COUNTY OF SAN MATEO
RECONSTRUCTION OF SEVENTH AVENUE FROM MIDDLEFIELD ROAD
TO EDISON WAY IN THE NORTH FAIR OAKS AREA
COUNTY ROAD NUMBER 561-A

COUNTY PROJECT NO. RW703
PROJECT FILE NO. E4957000

ADDENDUM NO. 2

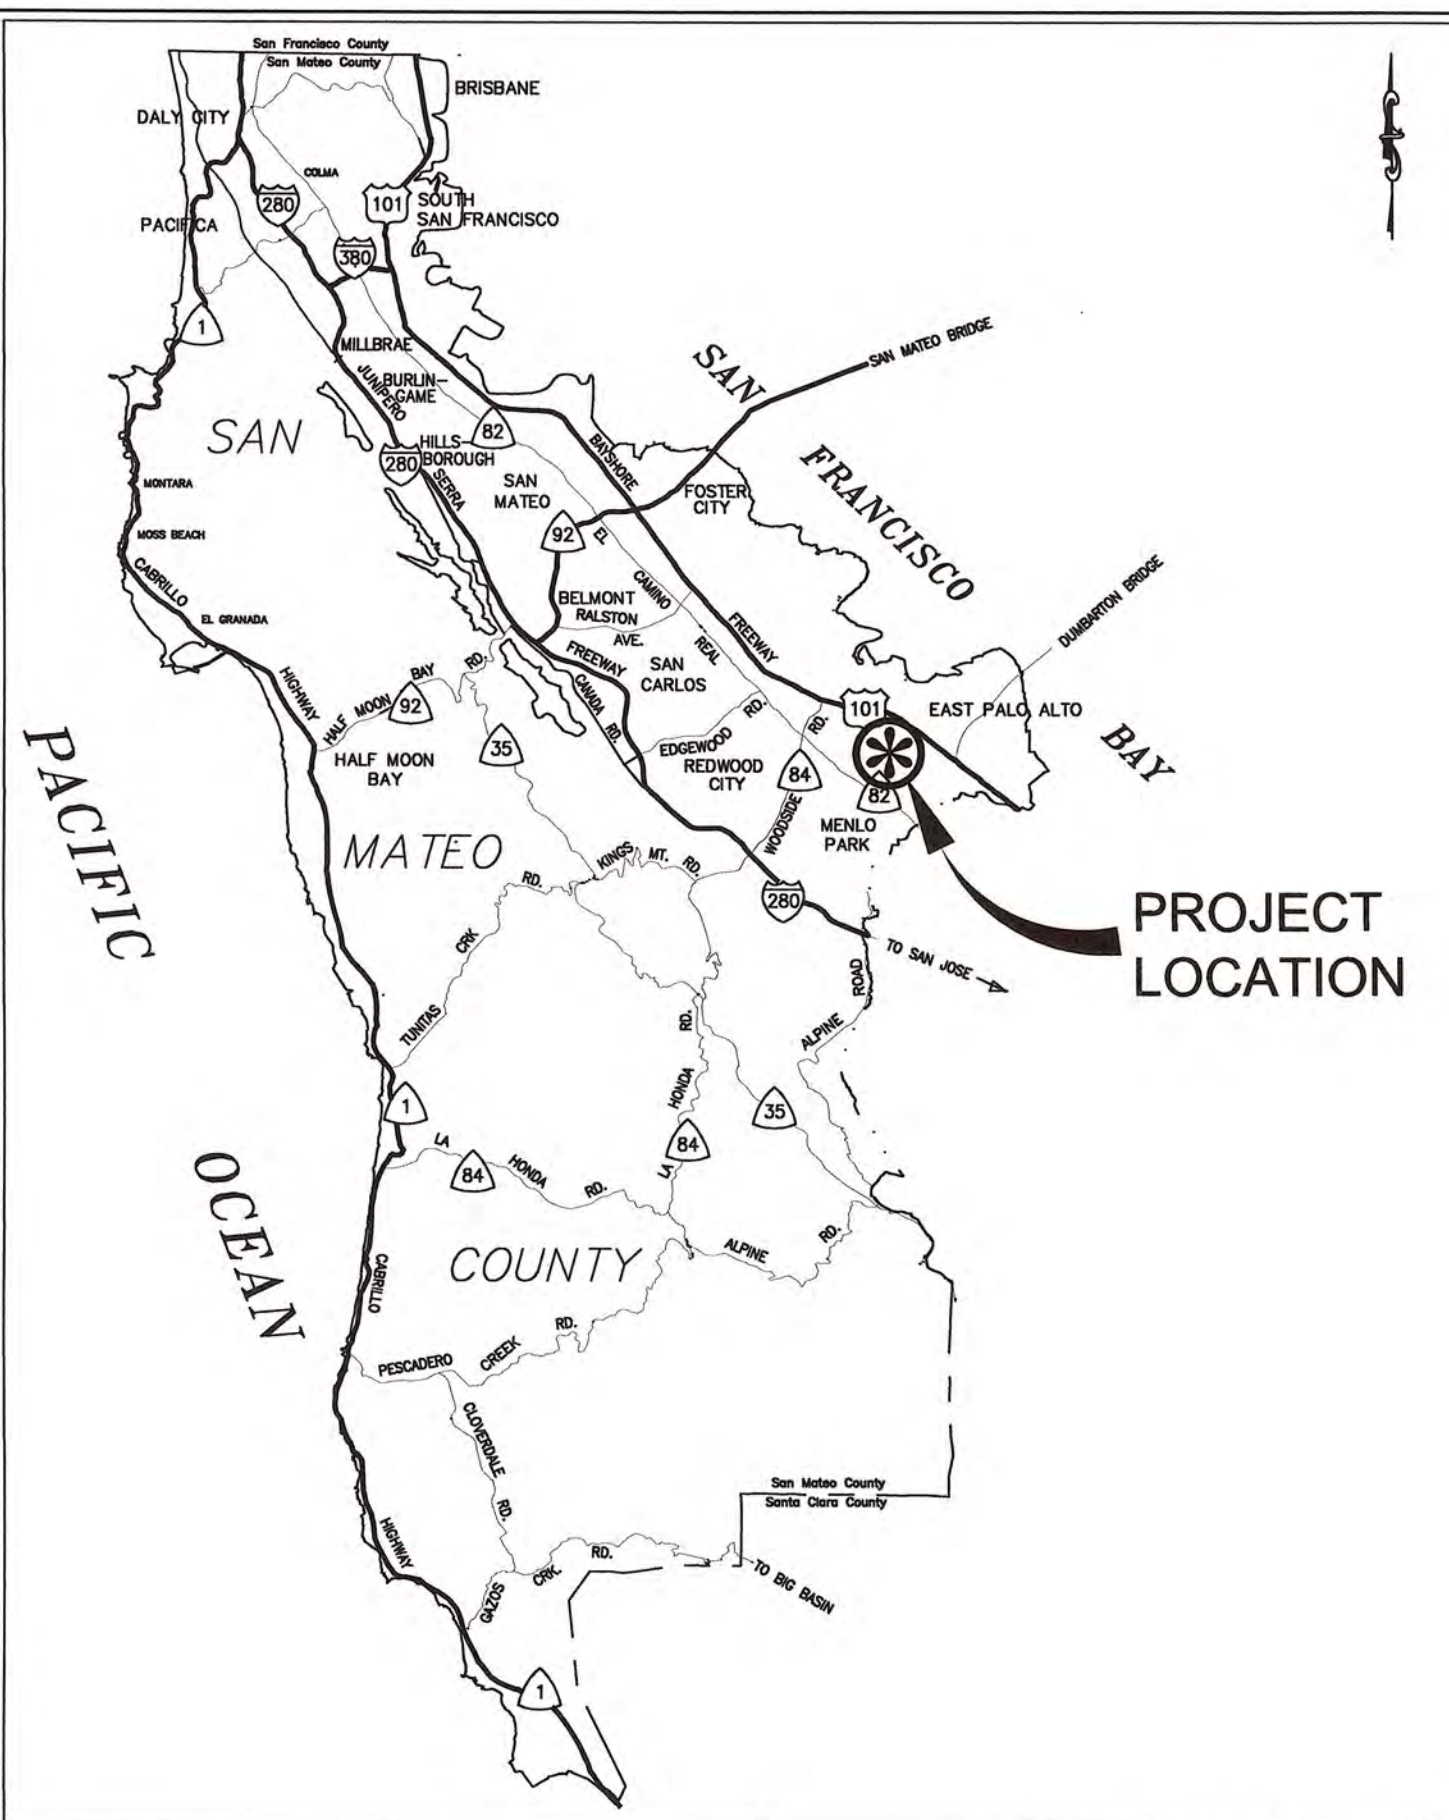
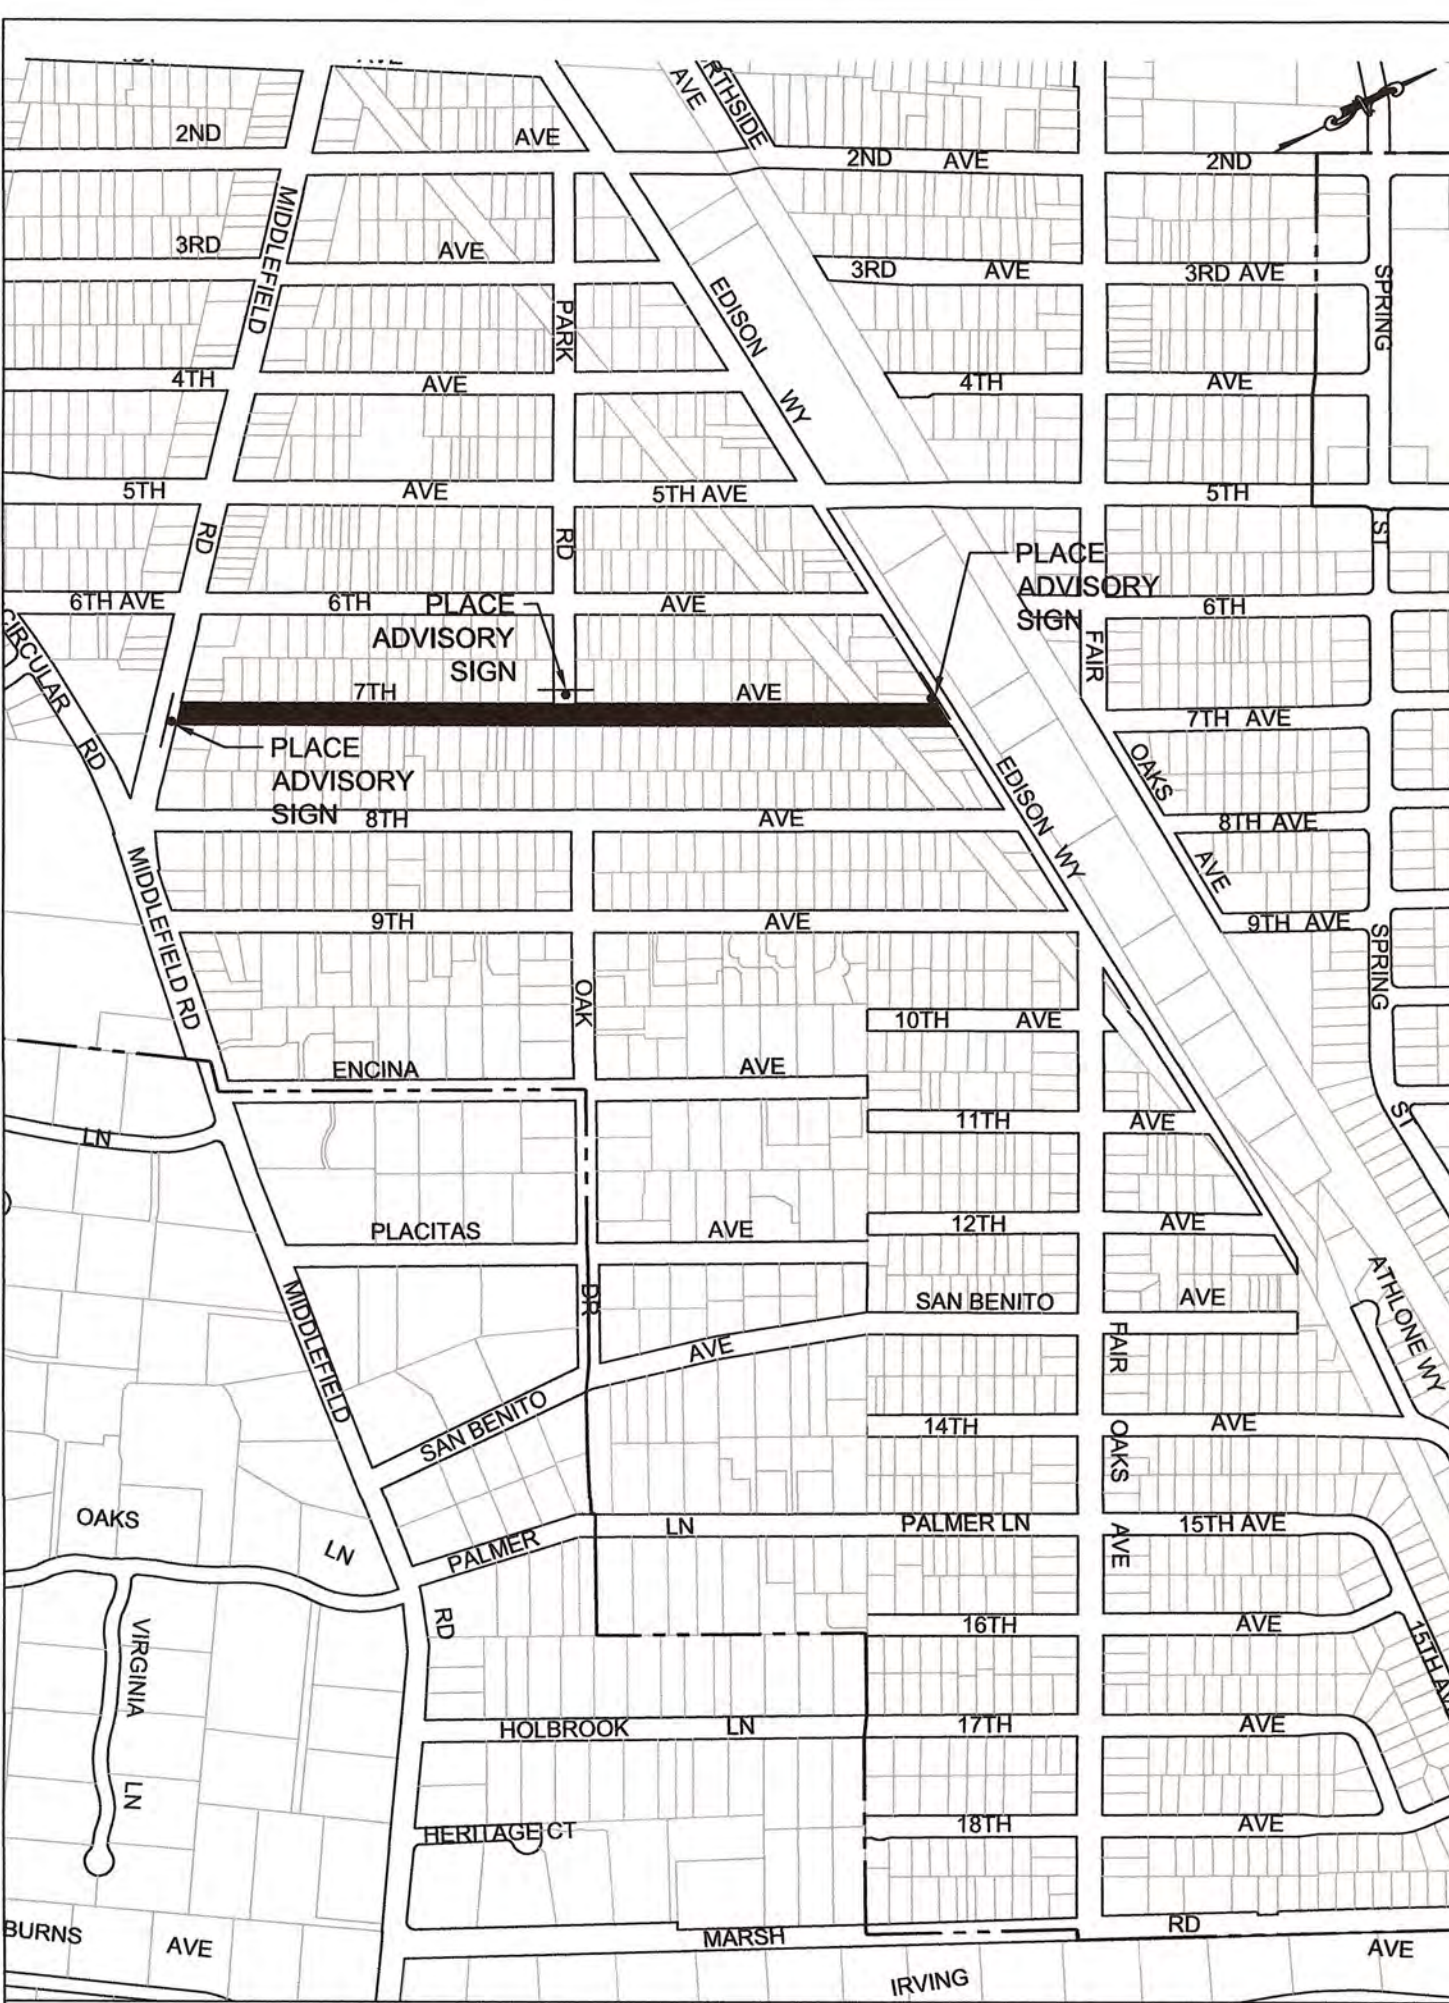
UPDATES:
1) HATCH PATTERNS DARKNESS ADJUSTED TO MATCH THE PLAN AND LEGEND
2) "ASPHALT CONCRETE" LABEL CHANGED TO "MISCELLANEOUS ASPHALT CONCRETE" LABEL

3 (REV)
 SHEET 3 OF 15

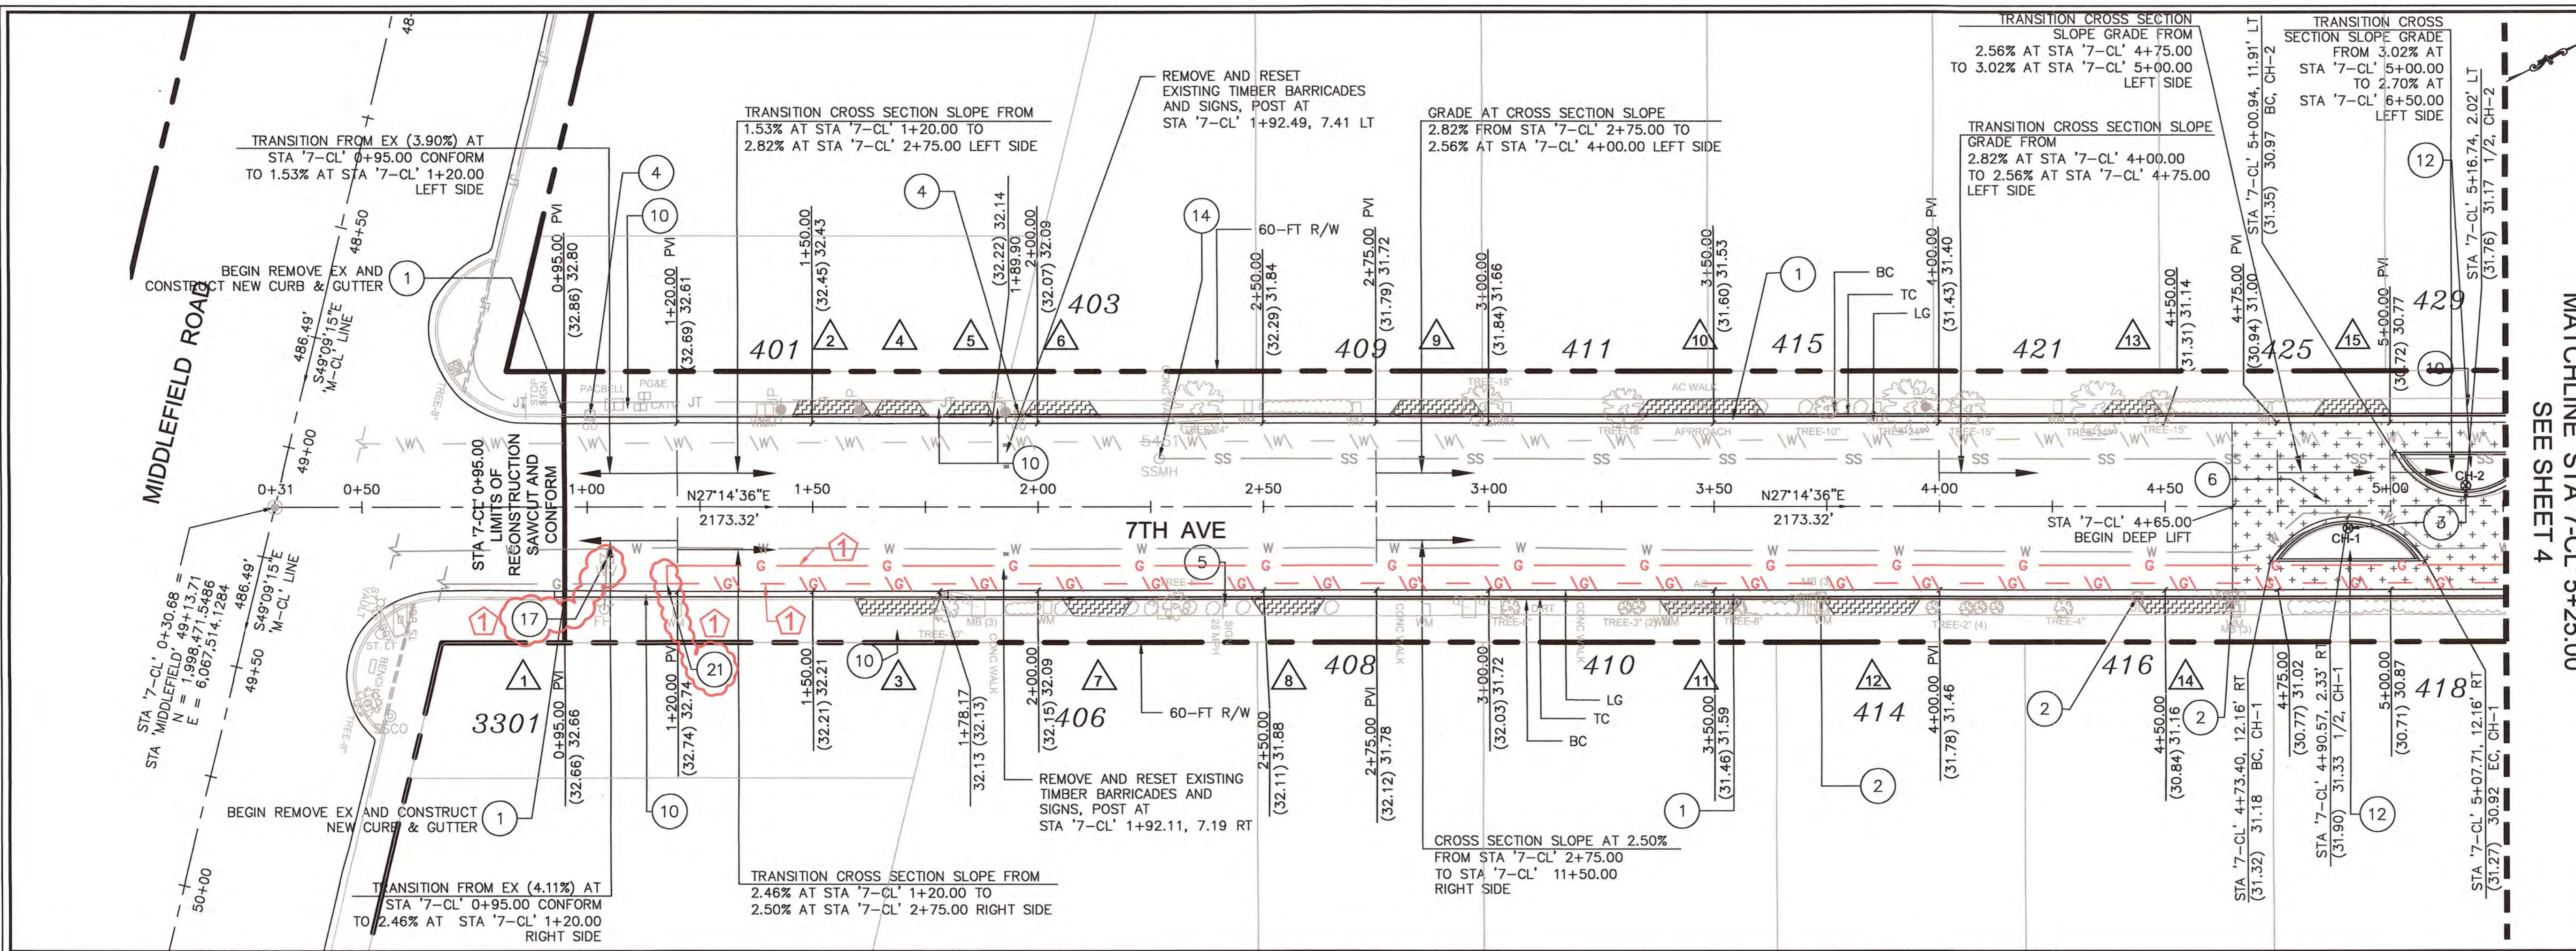
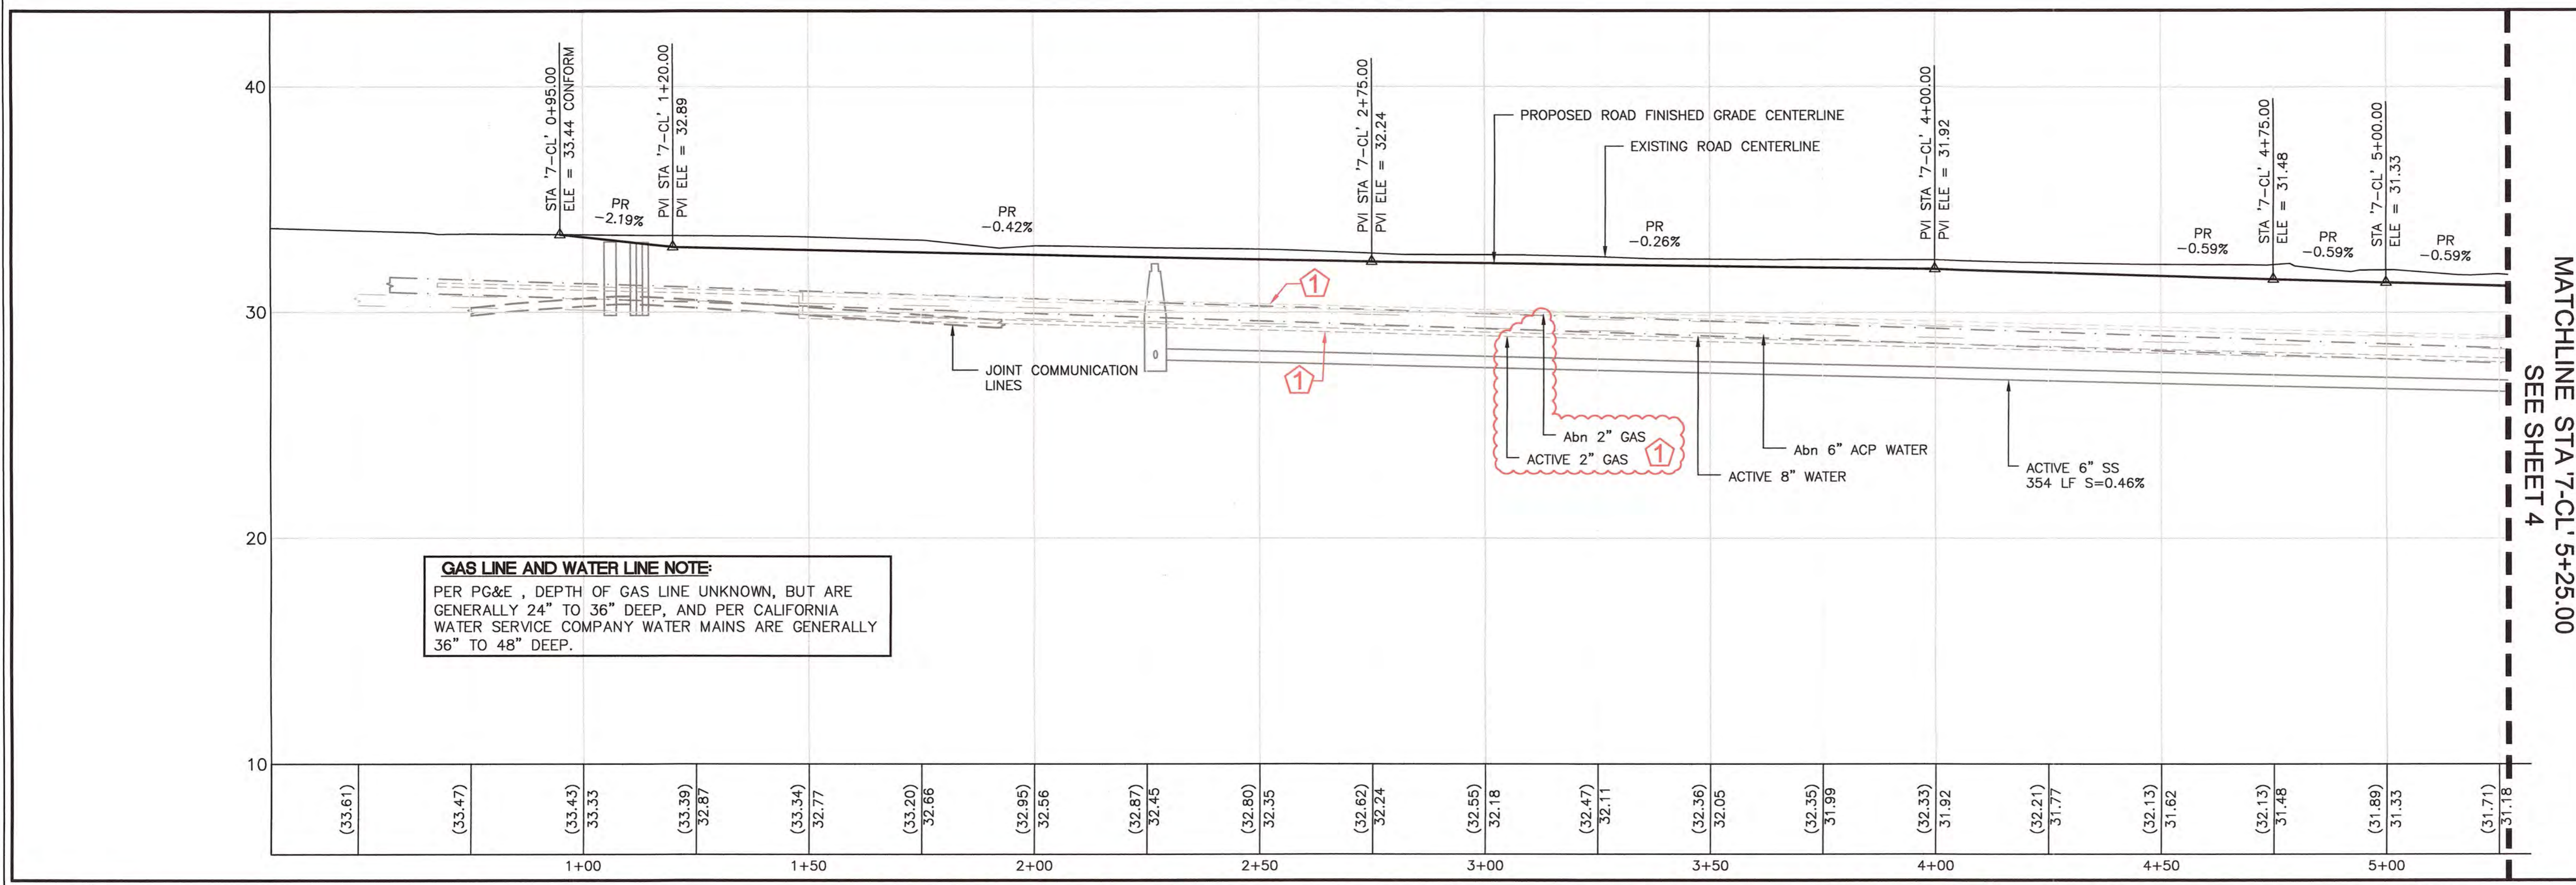
UPDATES:
 1.) HATCH PATTERNS DARKNESS ADJUSTED TO MATCH THE PLAN AND LEGEND
 2.) "ASPHALT CONCRETE" LABEL CHANGED TO "MISCELLANEOUS ASPHALT CONCRETE" LABEL
